ADDENDUM NUMBER 04

**PROJECT: LAUDERDALE COUNTY INNOVATION CENTER
GMC PROJECT NO. ABHM210017**

ADDENDUM #04

Bernhard TME Project No. 12-22-0082
Client Project No. ABHM210017

4 ENLARGED PLANS - MEN 399, WOMEN 394, JAN 400 & TLT 393 - PLUMBING
SCALE: 1/4" = 1'-0"

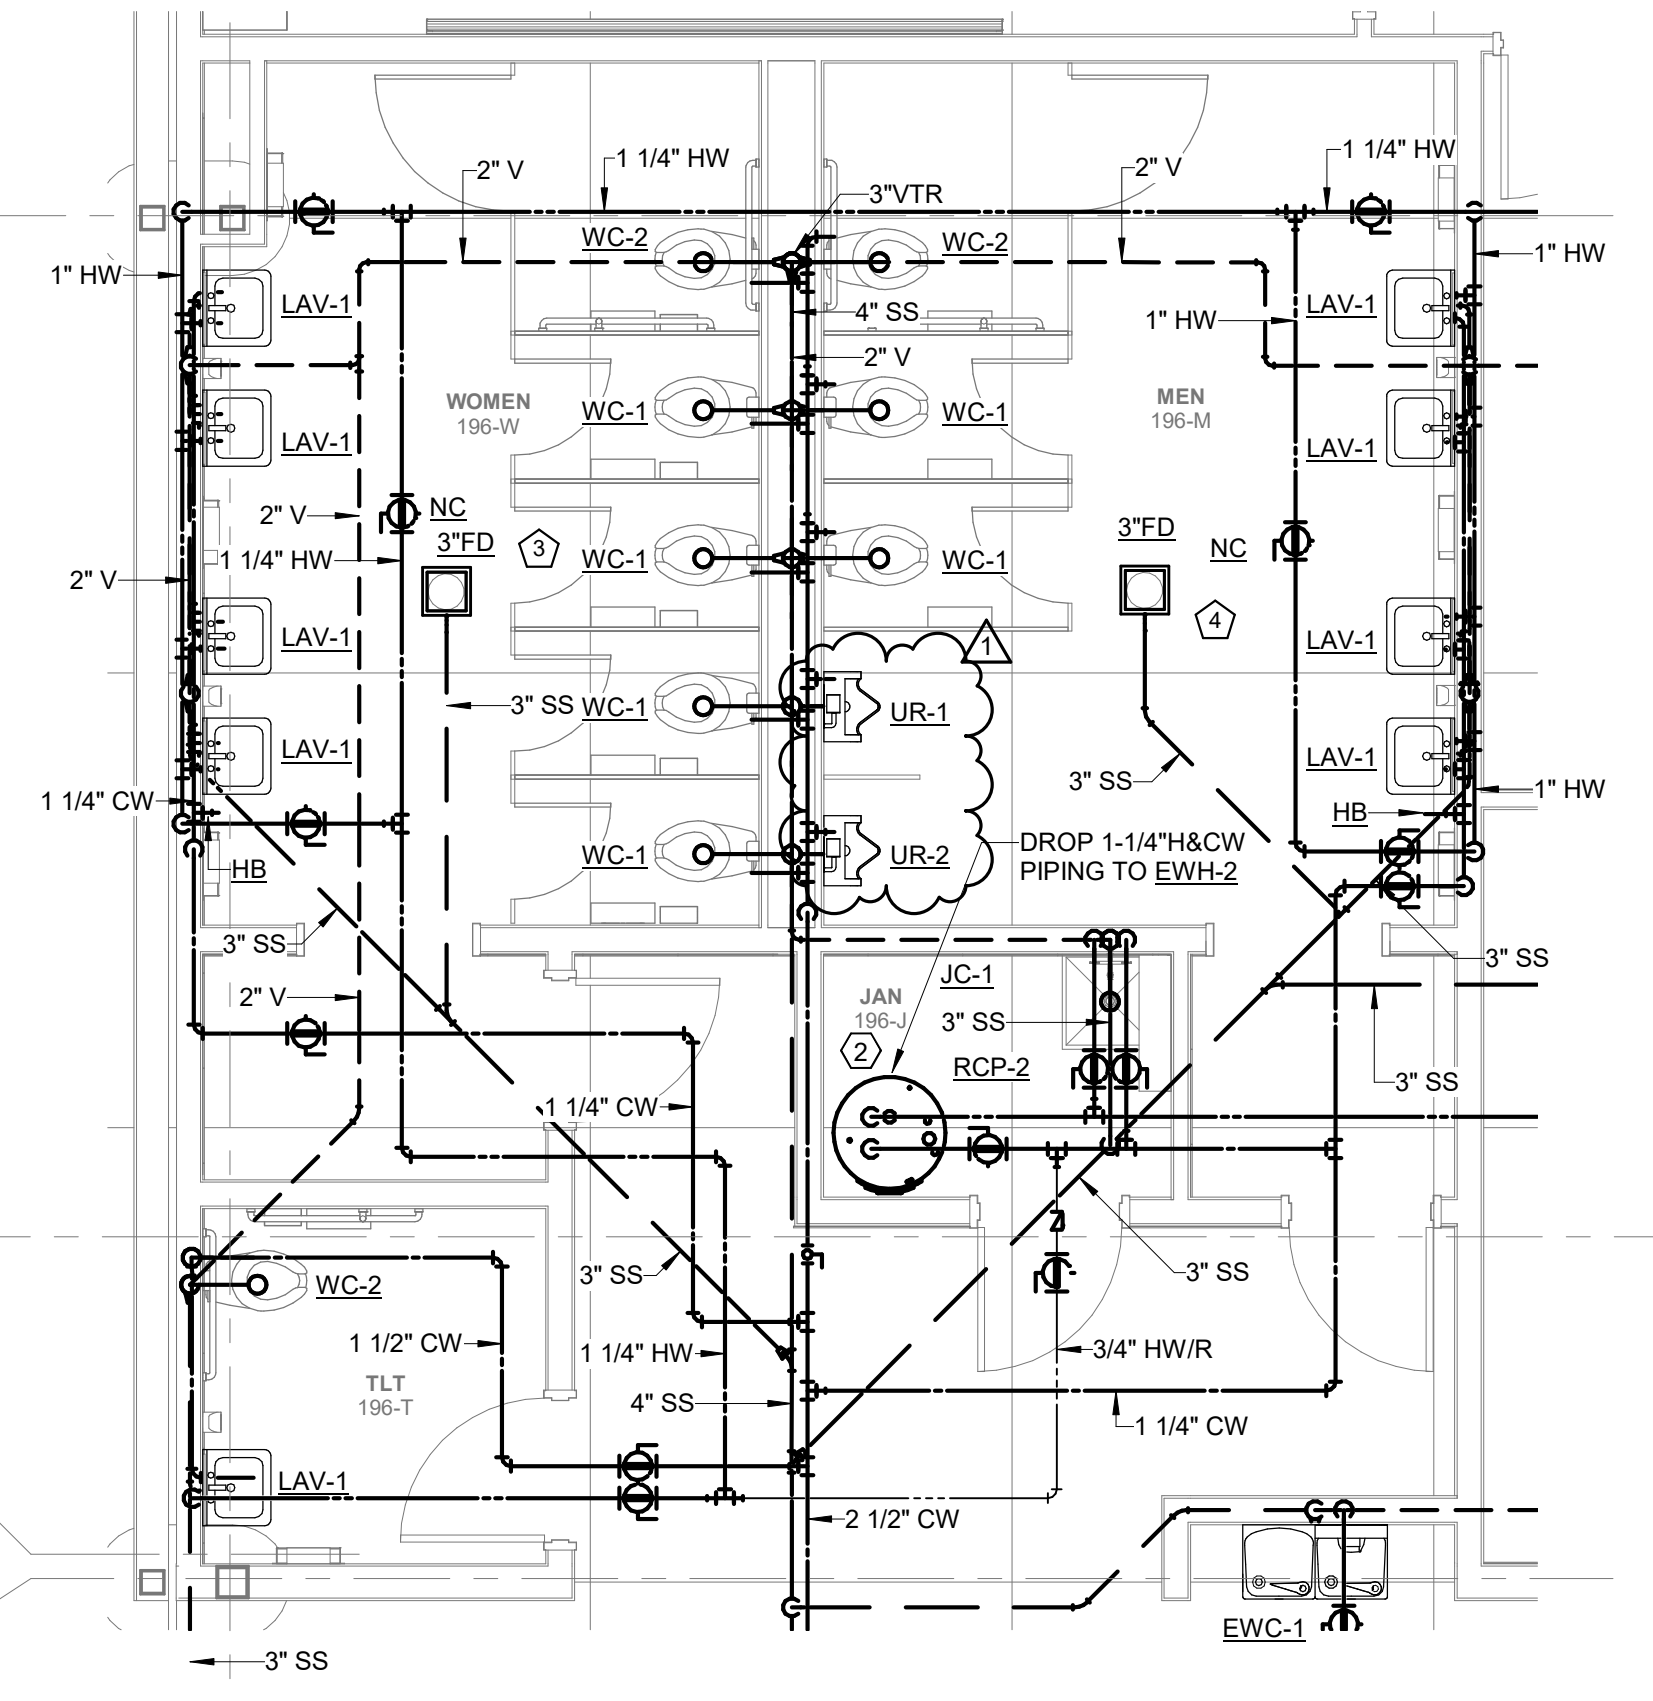
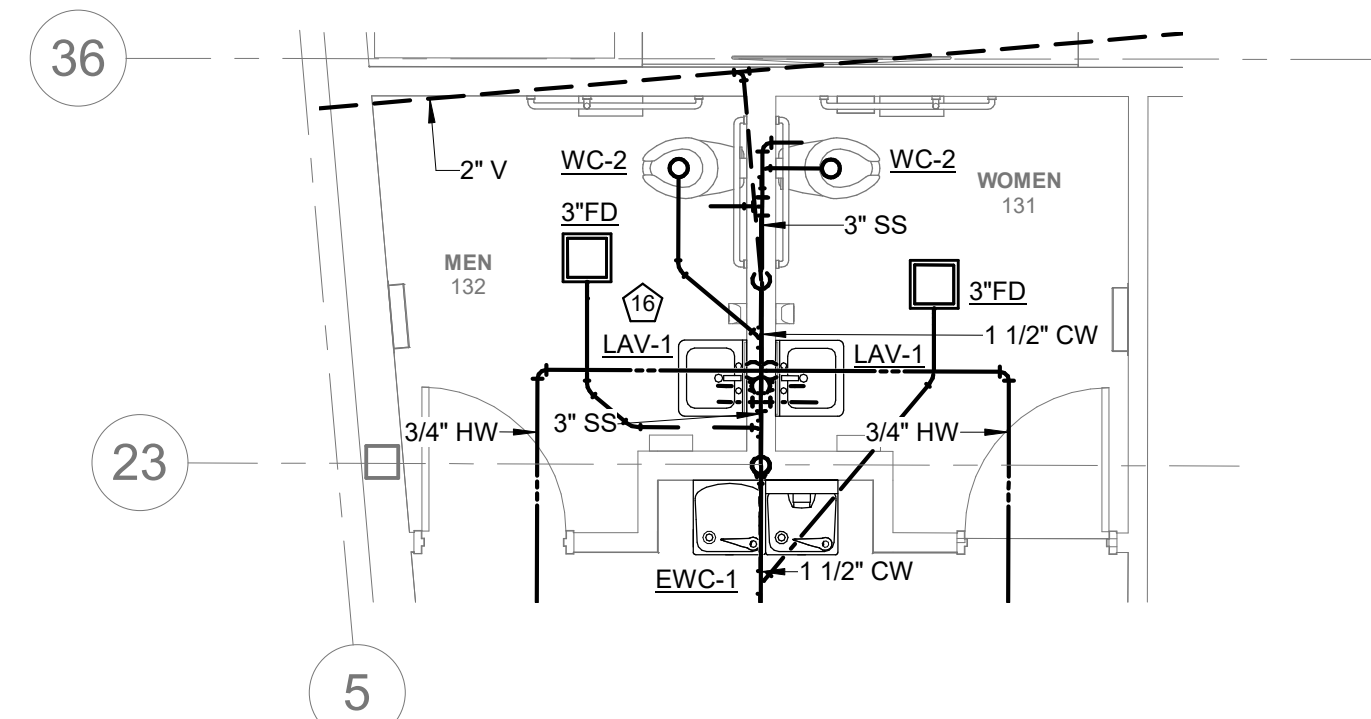
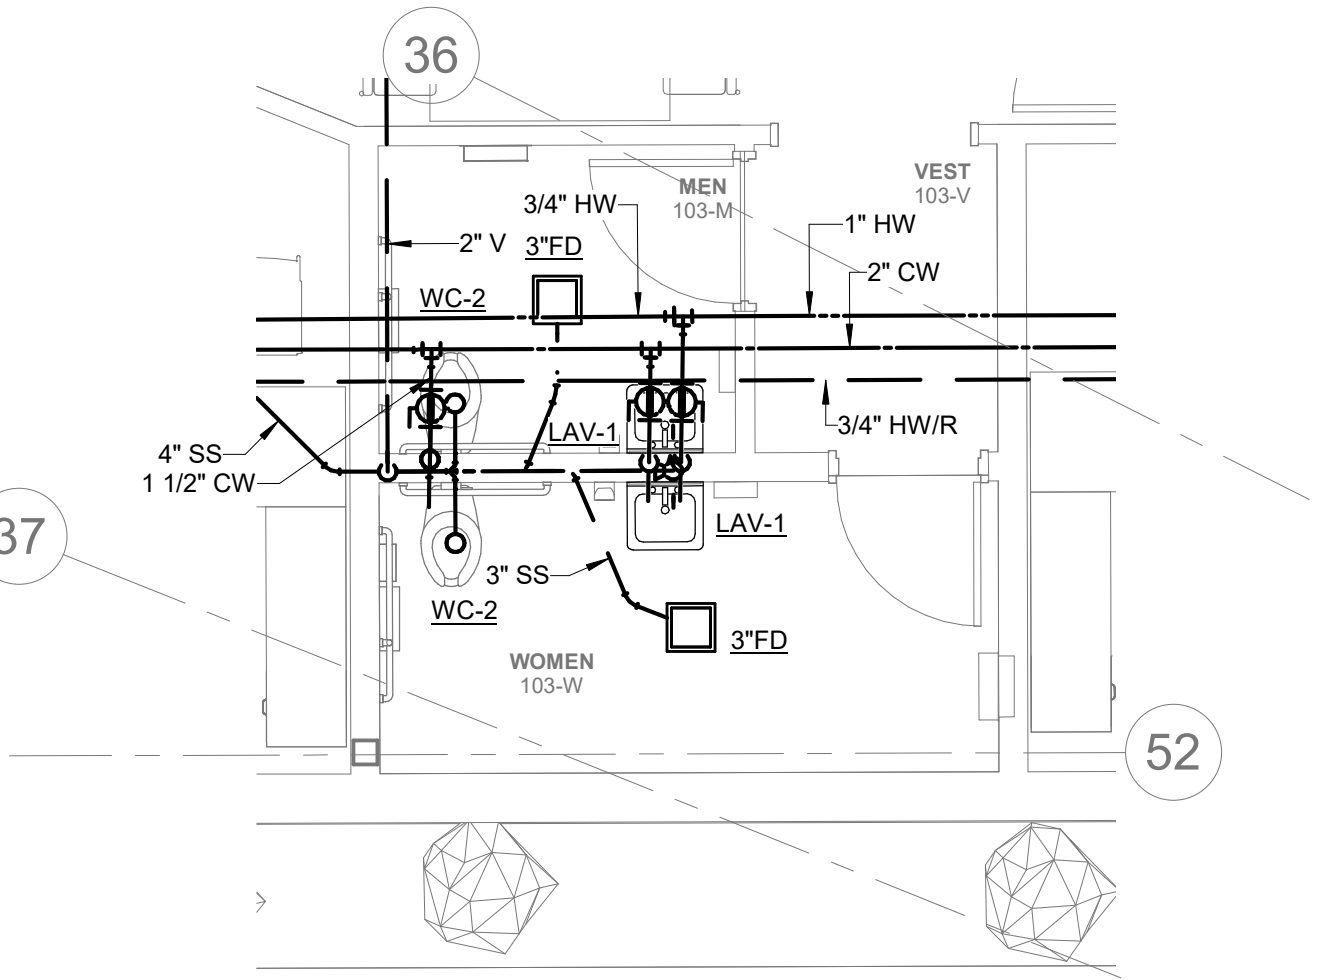
6. Refer to Revised Sheet (P2.07) – (PARTIAL FLOOR PLANS – PLUMBING PIPING) – revision dated (2023-11-03):
 - A. **REVISE** ADA urinal locations.
